TO: Freightliner Principals, General Managers, Sales Managers, Service Managers, Parts Managers	FROM: Anthony Washington, Department Manager, Regulations and Certifications
Re: Launch Recall Campaign Notification Model 907 (Sprinter) Model Years 2019-2020 Inspect Power Steering Hose Clamps	DATE: May, 2021

Campaign No. 2021050003, May, 2021

SUBJECT: **Model 907 Sprinter, Model Year 2019-2020**
Inspect Power Steering Hose Clamps

Order No. V-RC-2021050003

D46.25-A008-79

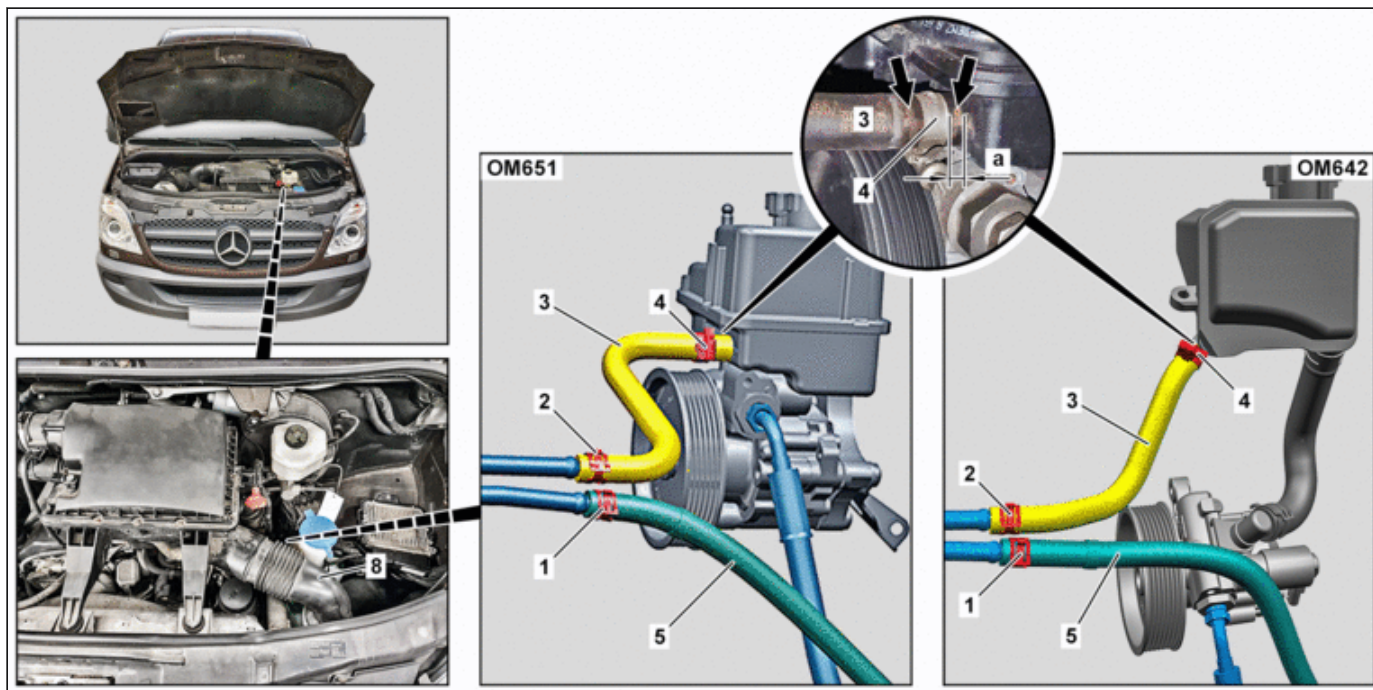
All 3 clamps (1, 2, 4) together with the listed connections must always be checked.

On vehicles with engine 642, the as-built configuration may deviate slightly (see first picture), which does not impair the procedure shown here.

2	Remove air ducting (8).		
3	Check hydraulic hoses and clamps (1, 2) of power steering.	<p> Check the following points: → Check both connections of hydraulic lines for leak tightness. → Check installation position of clamps (1, 2) on respective hydraulic hose. The clamps must be seated centrally between the markings (arrows) on the hoses. Also check whether the distance indicated by dimension (b) is maintained. See specification in picture.</p> <p>If clamps (1, 2) are not correctly positioned or if there is a leakage (see fail image above), ↓ replace affected clamp (1, 2). To do so, see operation step 5 onward in reference document. Replace clamps on hydraulic hoses of power steering (code: NV3LETULPX, acc. no.: 46 950 80)</p>	<p>SM46.25-D-0032-02SG</p>

4	Check return hose (3) and clamp (4) at power steering expansion reservoir.	<p> Check the following points:</p> <ul style="list-style-type: none"> → Check connection of return hose (3) at power steering expansion reservoir for leak tightness. → Check whether return hose (3) is pushed on power steering expansion reservoir up to end stop. → Check installation position of clamp (4) on power steering expansion reservoir. The clamp (4) must be seated centrally between the markings (arrows) on the return hose (3). See specification in picture. If markings (arrows) are no longer visible, then check distance against dimension (a). <p>If clamp (4) is not positioned correctly or if a leakage is present,</p> <p style="text-align: center;">↓</p> <p>reposition affected clamp (4). To do so, see operation steps 1 to 4 in reference document.</p> <p>Replace clamps on hydraulic hoses of power steering (code: NV3LETULPX, acc. no.: 46 950 80)</p> <p>If all specifications and test criteria of operation steps 3 and 4 are fulfilled,</p> <p style="text-align: center;">↓</p> <p>install air ducting (8) and end measure.</p>	SM46.25-D-0032-02SG

D46.25-A009-76

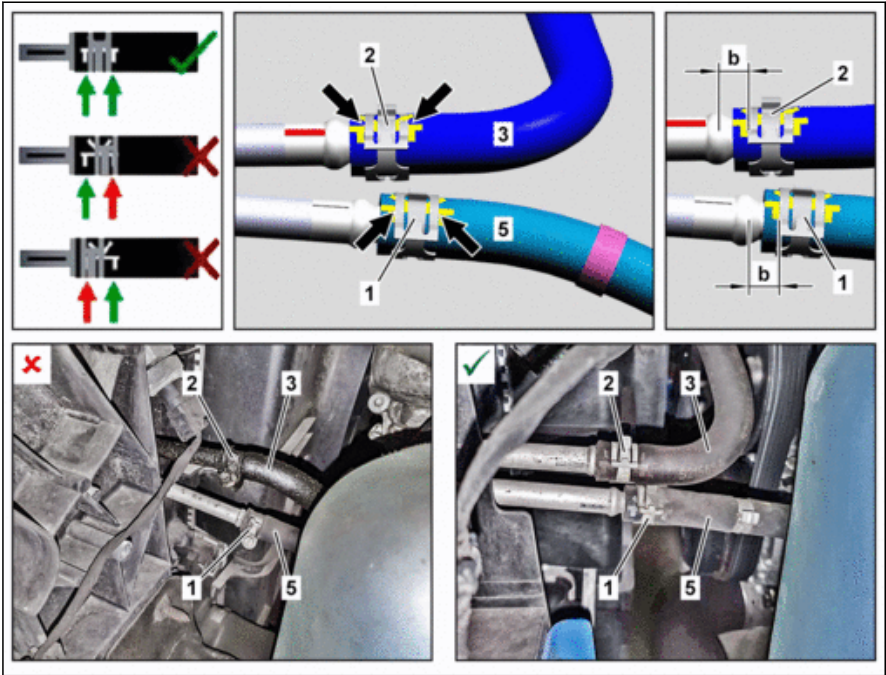
- 1

Clip
- 2

Clip
- 3

Return hose
- 5

Low-pressure hose
- b

Dimension (2 to 7 mm)
